Application for Rule Authorization of Underground Injection Control Facility

**Quil Ceda Village
Treated Effluent Infiltration System**

RE: Quil Ceda Village Treated Effluent Infiltration System: Inventory and Assessment for Rule Re-authorization and amendment

Re: UIC Application for Authorization by Rule
Quil Ceda Village Project
EPA Project # 4-25-5x-00743

WEST #1 INFILTRATION STAND PIPE: Pipe NE corner

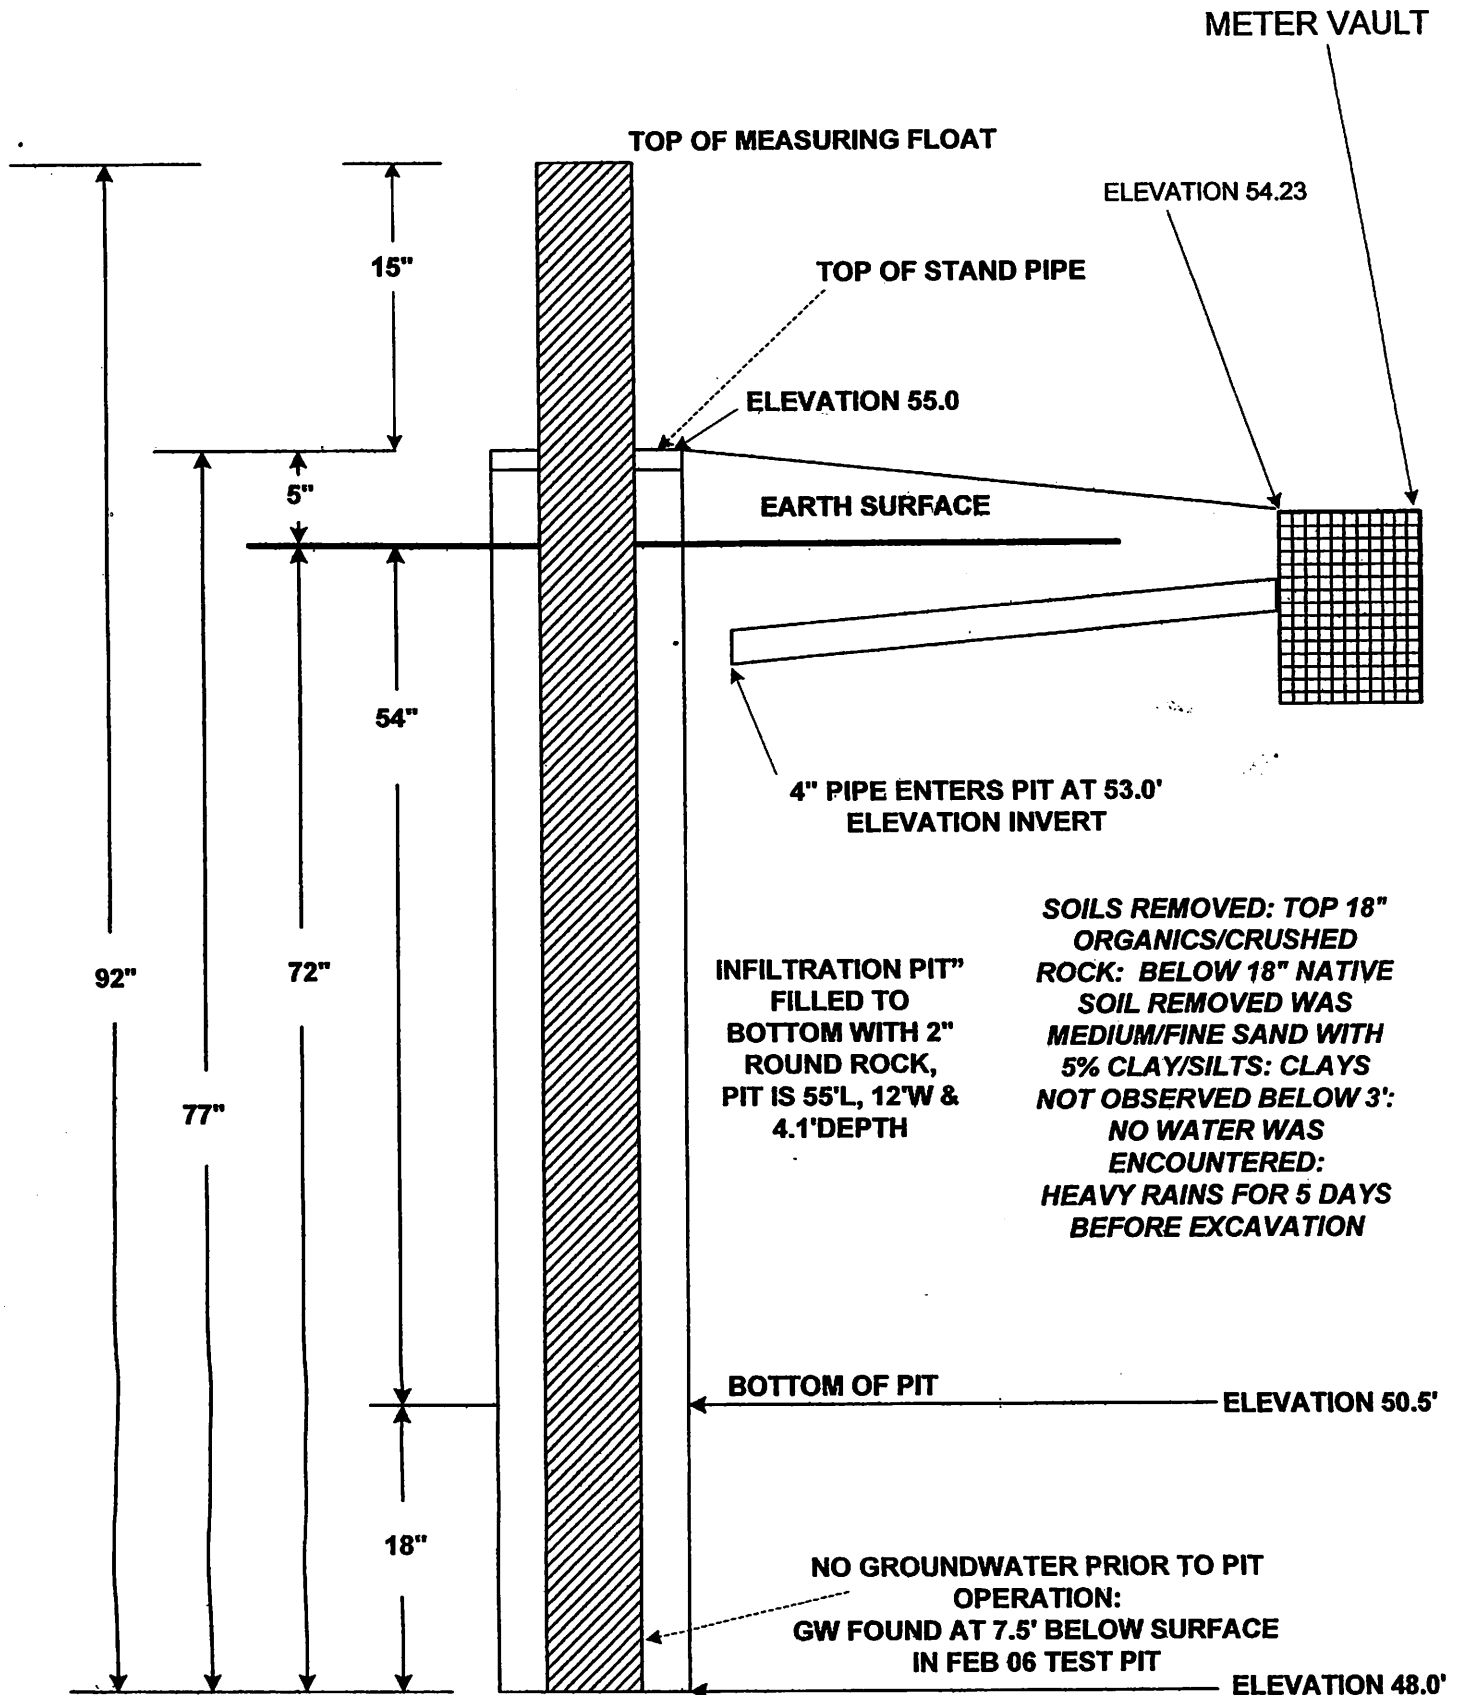
5. The item entitled, "West #1 Infiltration stand Pipe: Pipe NE corner," is provided to show how the piezometer tubes are to be installed in the new infiltration trench.

No.	Change	Date:	Constructed Wetland	QUIL CEDA VILLAGE	NAME: WETLAND INFILTRATION PITS	Sheet No
			PROJECT # UT06-003	TULALIP, WA		1 / 5

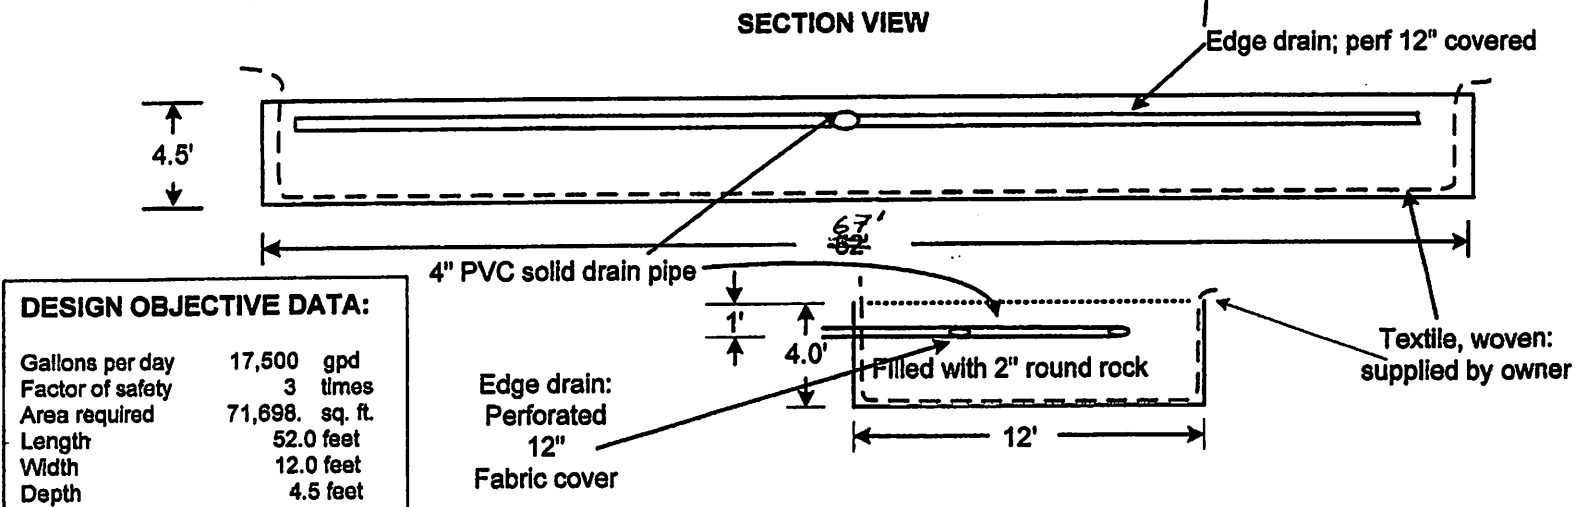
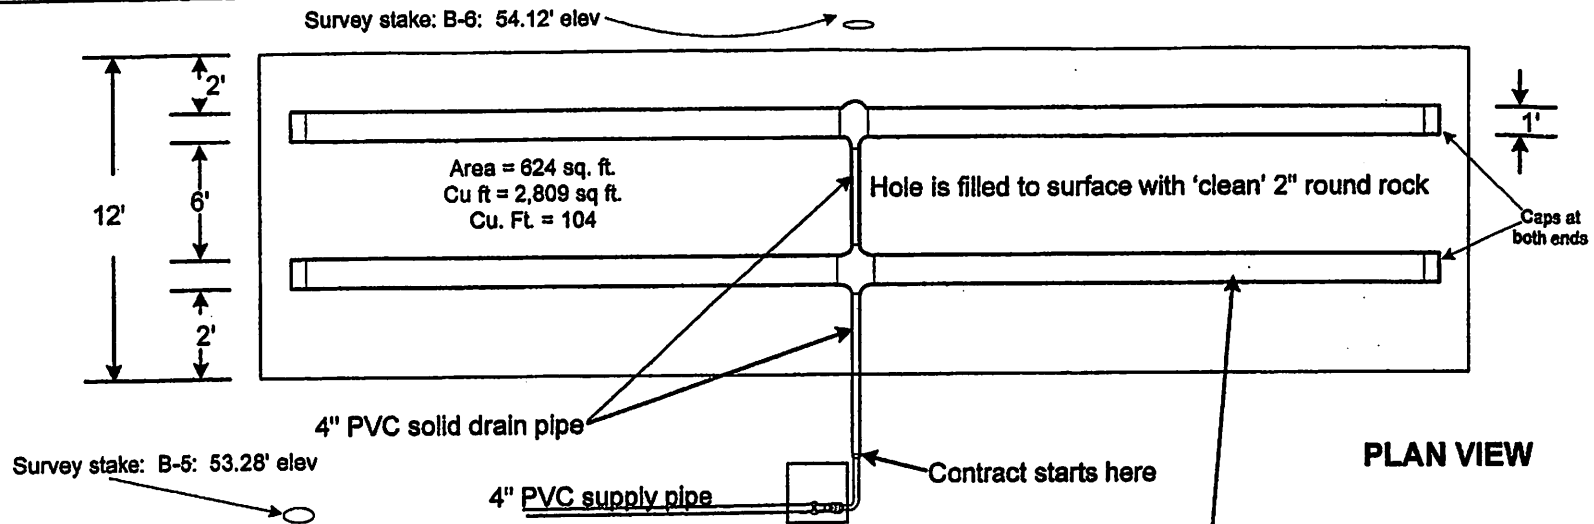
1. Page R-3, under Project, add, "The ½-inch plywood covers as shown on the drawings will be supplied by others."
2. The drawings shall depict the gabion baskets filled with 2" to 4" sized rock. The Bill of Materials should be adjusted to reflect the addition of this rock and the lesser amount of 3/8-inch pea gravel needed.

3. Page R-3, under Project, add, "Geotextile shall be placed beneath the gabion baskets to protect the liner from being punctured by the rock-filled gabion baskets."
